ADDENDUM NO. 2

To the Drawings and Project Manual dated 16 June 2017

**TAS/ADA FIRE MARSHAL
DEFERRED MAINTENANCE PROJECTS
MIDWESTERN STATE
UNIVERSITY**

**BOLIN SCIENCE HALL - FIRST FLOOR - AREA 1A
MECHANICAL PLAN**

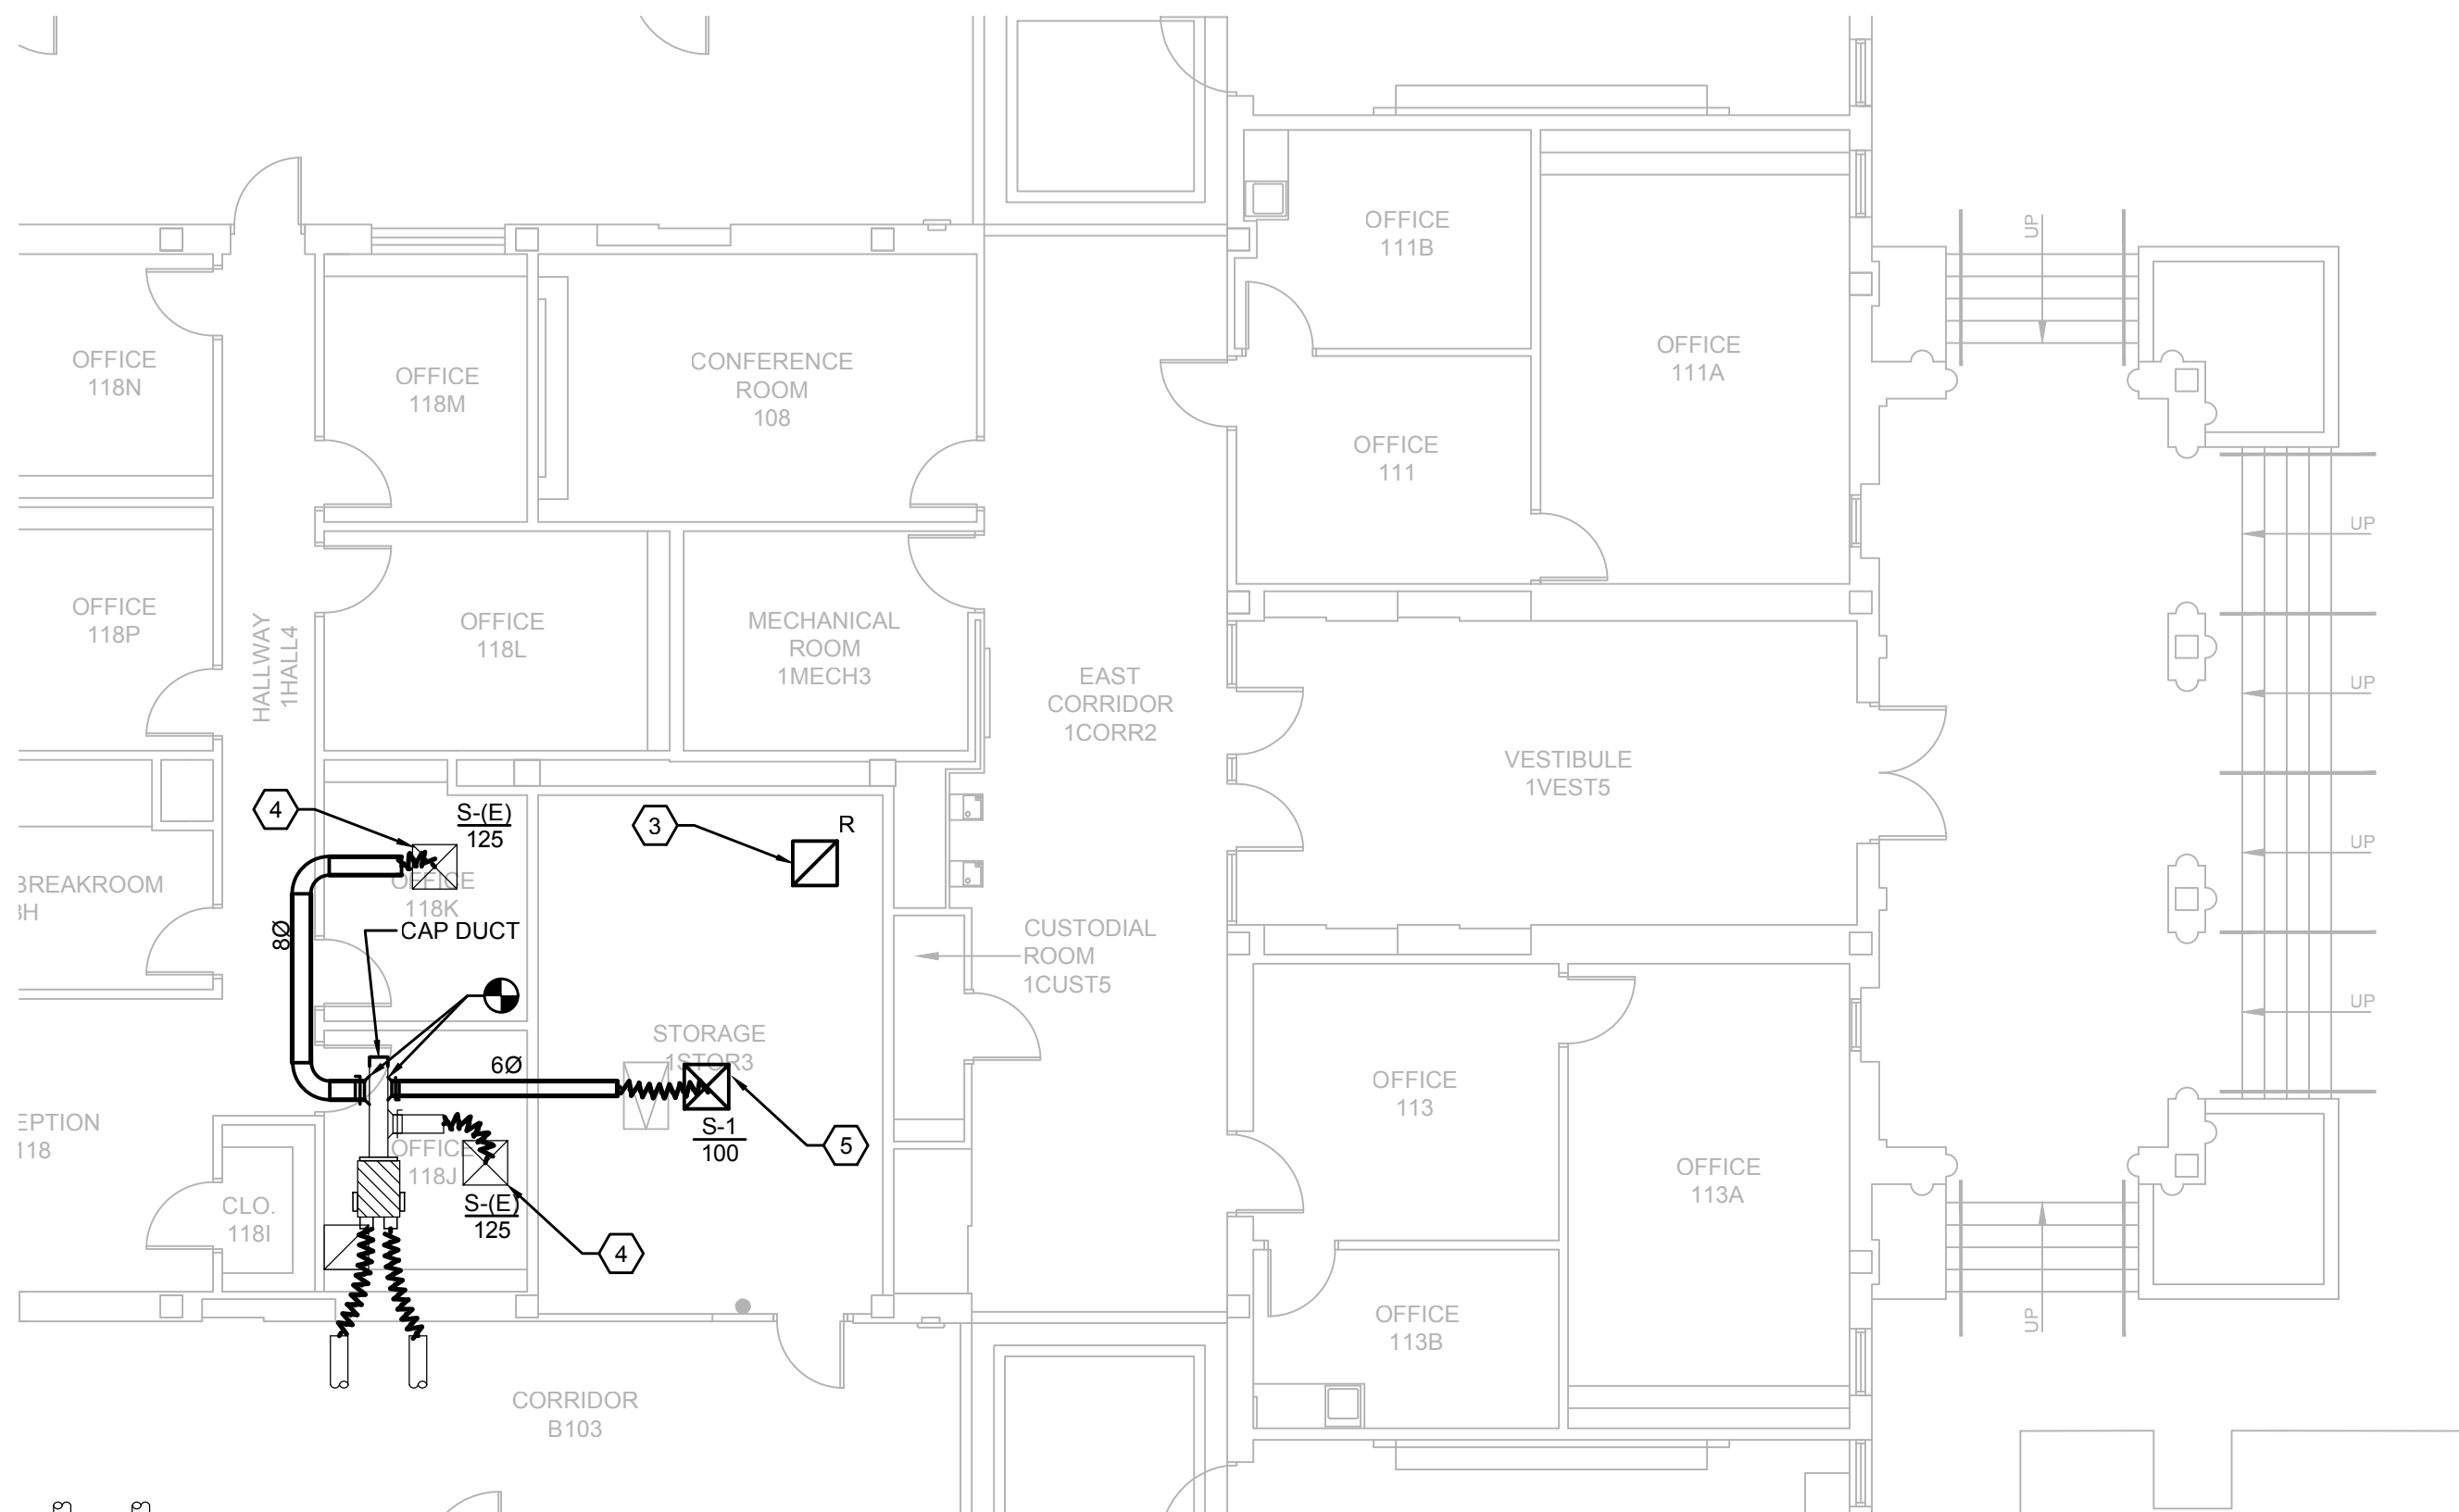
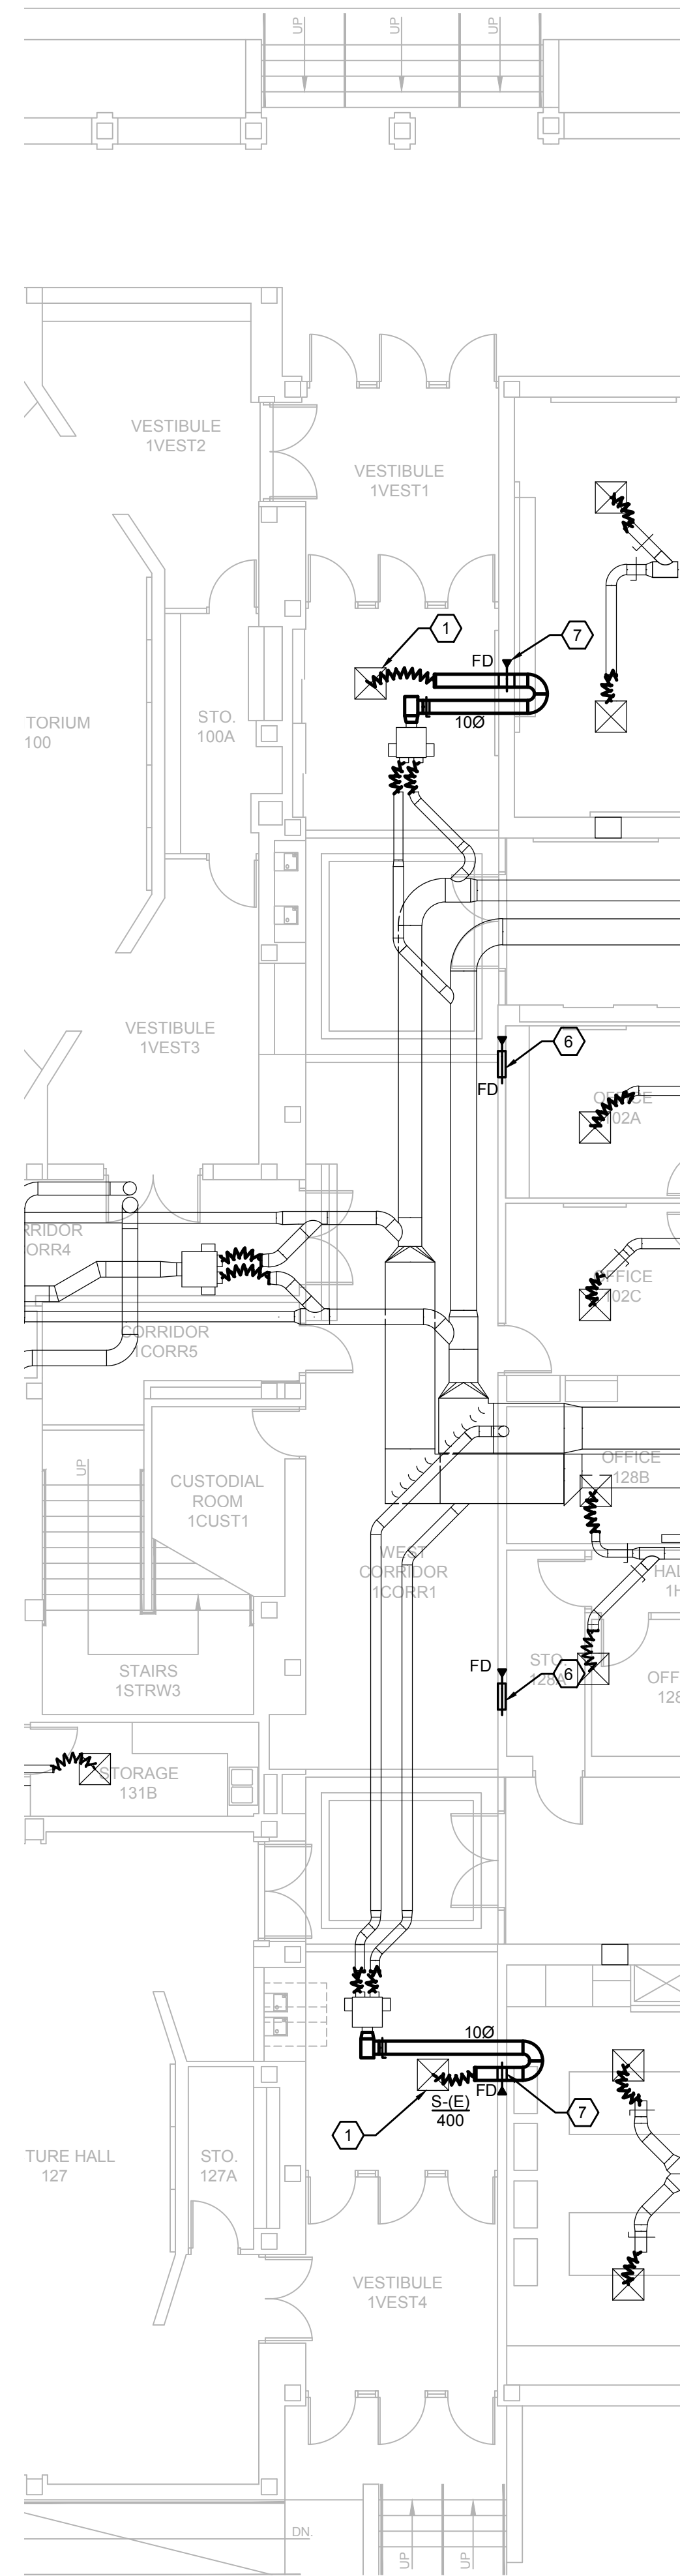
1. Sheet B-MD101– Revised Drawing as follows:
 - a. Rearrange sheet details to include HVAC demolition work in Area C1. It includes demolition of the supply and return ductwork serving the corridor as preparation for the inclusion of fire dampers.
2. Sheet B-M101– Revised Drawing as follows:
 - a. Rearrange sheet details to include HVAC work in Area C1. It includes new Key Notes #6 and #7 to call for the installation of fire dampers on the supply and return ductwork in the corridor.

- INSTALL NEW FIRE DAMPER IN RETURN AIR DUCT, SIMILAR TO RUSKIN DIBD20G, 20X10. AND RETURN GRILLE SIMILAR TO TITUS 359RL, 20X10. PROVIDE ACCESS DOOR TO FIRE DAMPER IF INSTALLED IN A HARD CEILING AREA.

- INSTALL 10" ROUND FIRE DAMPER SIMILAR TO RUSKIN FDR25 WITH ACCESS DOOR SIMILAR TO RUSKIN MODEL ADR1 FOR RESETTING THE FIRE DAMPER. PROVIDE ACCESS DOOR TO DUCTWORK IF FIRE DAMPER IS INSTALL IN A HARD CEILING AREA.

FP001

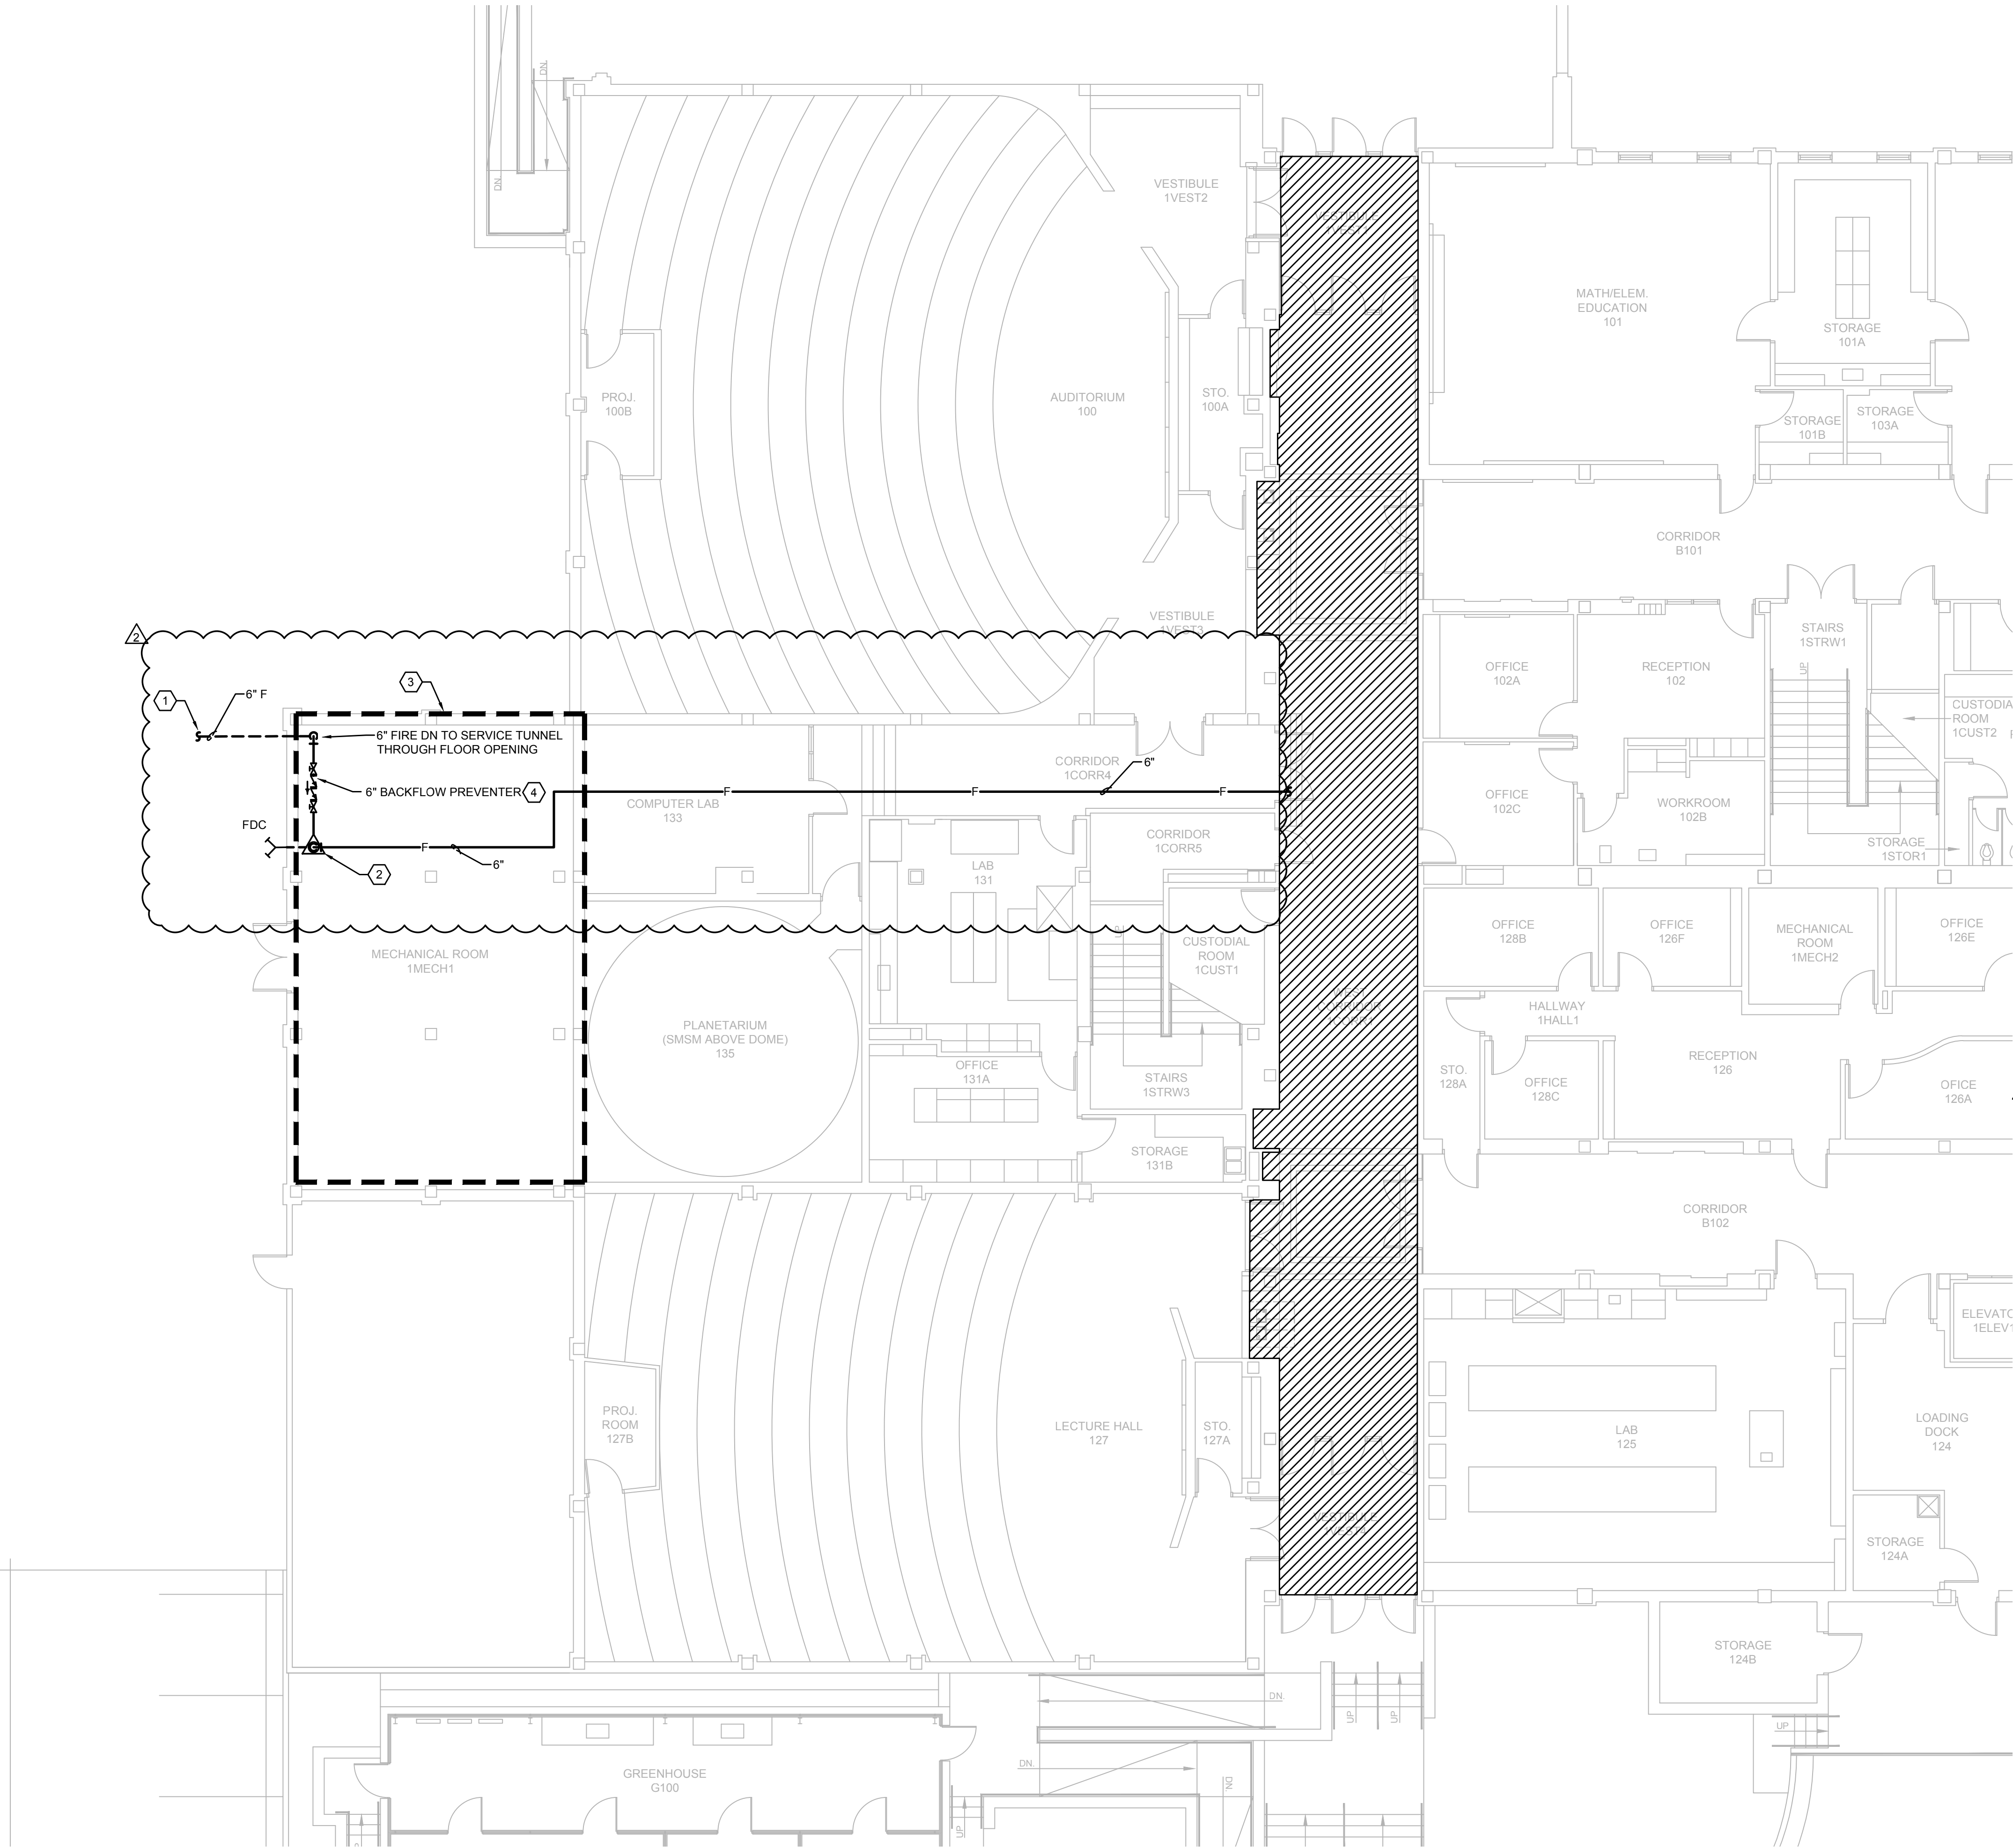
1. Sheet FP001 – Revised Drawing as follows:
 - a. Added Key note #27, to direct the contractor to coordinate with the General Contractor the removal of the reflected ceiling along with any electrical, HVAC or any other appurtenance associated with it. It also states to save those materials for reinstallation.
